**TOWN OF HORIZON CITY
Planning and Zoning Commission Staff Report**

Case No.: SUB-002460-2021
Horizon Manor Unit Three Replat "A"

Application Type: **Preliminary and Final Plat**

Attachment 4- Preliminary Plat

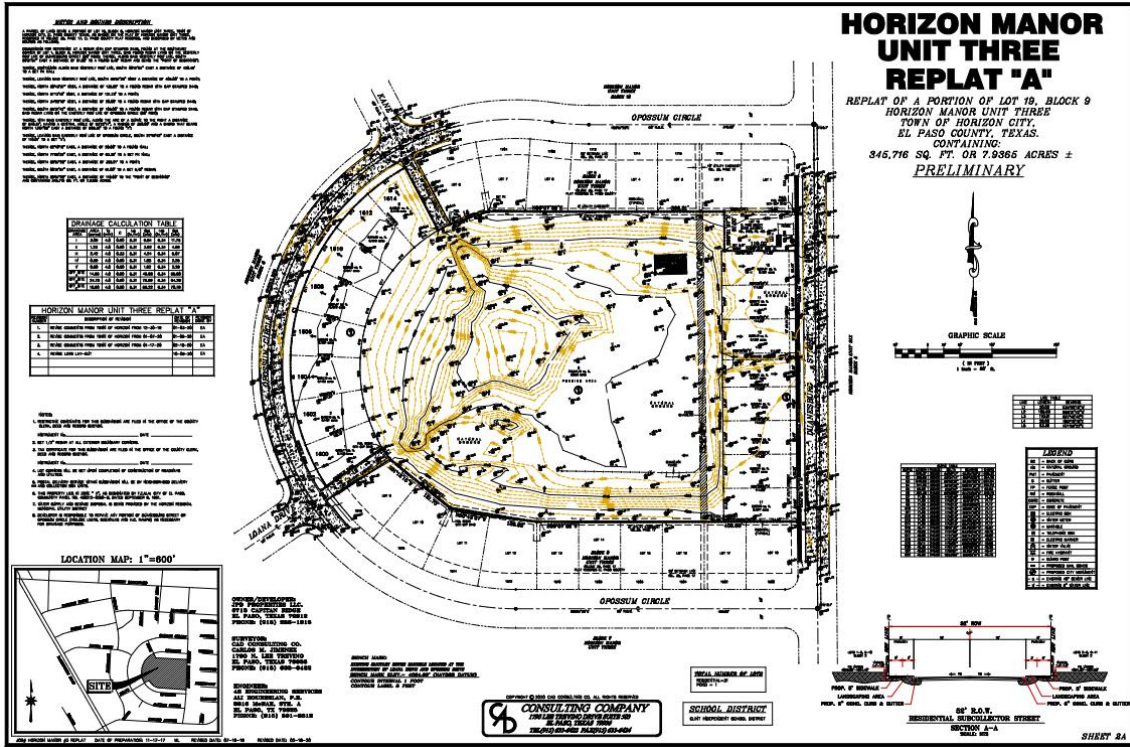
- If there is ponding to be dedicated, the dedication shall be included in the "Owner's Dedication, Certification and Attestation" statement.
- Staff continues to work with the applicant/developer to determine the City's share, if any, of the drainage improvements.
- Addresses shall be provided for lots 10 through 17, block 1 on both the preliminary and final plats.

1. Metes and Bounds description is missing Bearing N 89 57' 28'' E and Distance 110.00' at point of beginning.
2. Provide utility easements on Block 1 lots 1-8.
3. Provide Ponding capacity information/calculations. See Ordinance No.0035, 4.2.2.5 (7c.) and 4.2.2.6 (8c.) and 4.2.2.6 (8d.) and 4.2.2.7 (9).
4. Updated Drainage study/report to be submitted during the Subdivision Improvement Plan Review.
5. Show watershed areas.
6. On the note section #8, modify note stating the developer is responsible to repave/improve any portion of Duanesburg St. and/or Opossum Cir. (to include sidewalk, drainage easements, rock/retaining walls, drainage structures and H.C. Ramps) as necessary for drainage purposes.

1. Remove the cross-section for the Residential Sub-collector Street from the plat, included in the plat.
2. Update the drainage calculations table to reflect plat drainage areas.
3. It is not clear from the plat if the pond will remain private or be dedicated to the Town of Horizon City. Please clarify.
4. Update plat with revision date.
5. Coordinate with the Town of Horizon City with regard to any additional comments they may have.

- Lot 1 thru Lot 8 – provide 10' wide easement along frontage of all lots
- Lot 9 (ponding area) - Continue platted 5' wide utility easement along entire Access to ponding area converted to 20' wide drainage and utility easement
Future use? Developable?
Will it be requiring power?

Attachment 4- Final Plat

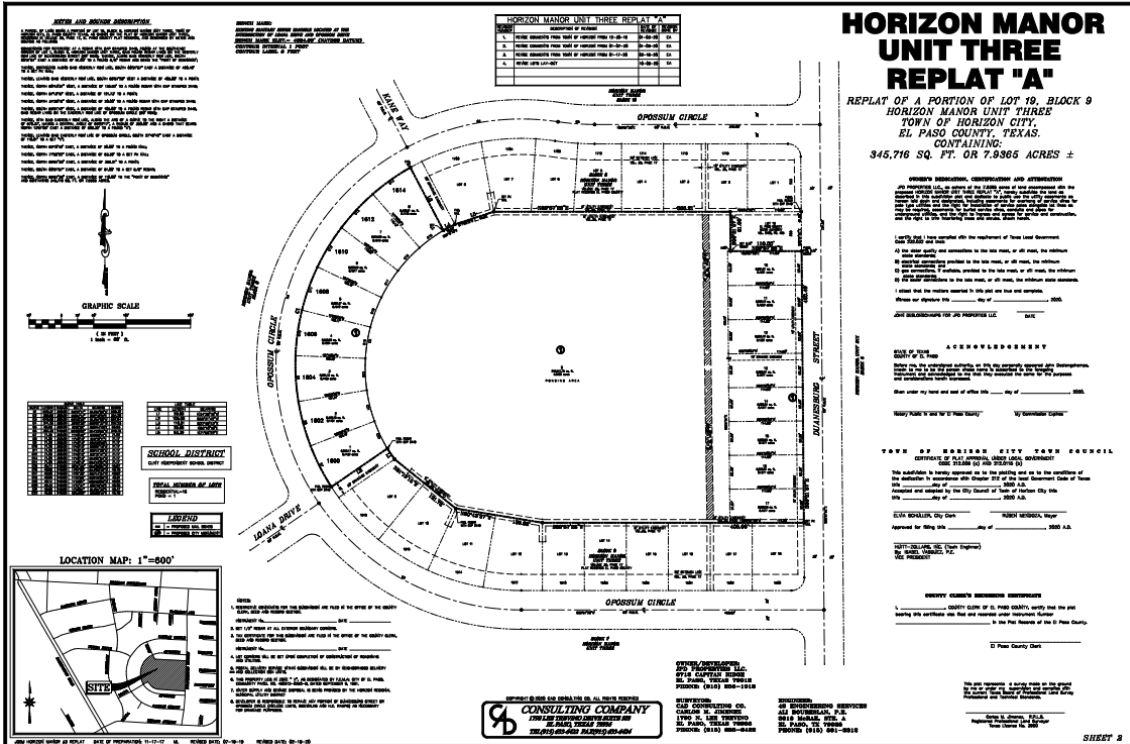
1. Metes and Bounds description is missing Bearing N 89 57' 28'' E and Distance 110.00' at point of beginning.
2. Provide utility easements on Block 1 lots 1-8.
3. Missing addresses on lots 10-17, Block 1, no address review. El Paso County 9-1-1 District approval is required.
4. Updated Drainage study/report to be submitted during the Subdivision Improvement Plan Review.
5. Provide A copy of the restrictions and covenants to be recorded, if any.

1. If the pond is going to be dedicated to the Town of Horizon City, include the pond in the dedication statement.

2. Update plat with revision date.
3. Revise dates in dedication and signature blocks to 2021.
4. Coordinate with the Town of Horizon City with regard to any additional comments they may have.
